Seeking views on Paragraph 6.21.4 of Regulation 48 (Installation of lighting and light-signalling devices)

The UK would like to seek the views of contracting parties on the application of conspicuity markings to the cabs of vehicles according to Paragraph 6.21.4.

Figure 1 Example of vehicle marking

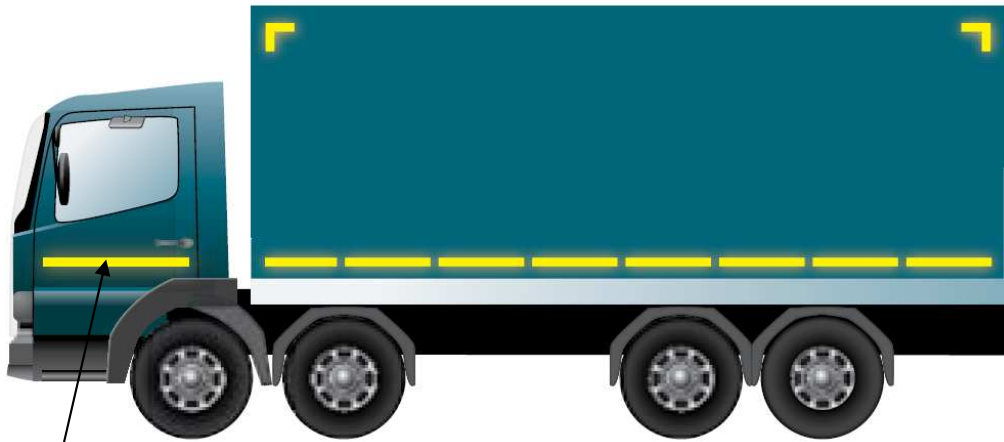
The current text of paragraph 6.21.4.2.1. requires that the conspicuity marking extends to within 600mm of each end of the vehicle. Figure 1 shows one possible interpretation of this requirement for a rigid vehicle fitted with a box body. In this example the line element of the marking extends onto the cab to comply with the requirement that the marking extends within 600mm of the front end of the vehicle.

However, paragraph 6.21.4.2.2.1, which specifies the cumulative length of the marking, excludes the cab from the calculation. This implies that the marking on the cab is not necessary, contradicting paragraph 6.21.4.2.1.

Before drafting a proposal to clarify the text the UK would be interested in views on:

- a) Whether the original intention was to exclude the vehicle cab in all cases and,
- b) If not, the reason to exclude the cab from the calculation of cumulative length.

Marking required on cab?
Paragraph 6.21.4.2.1
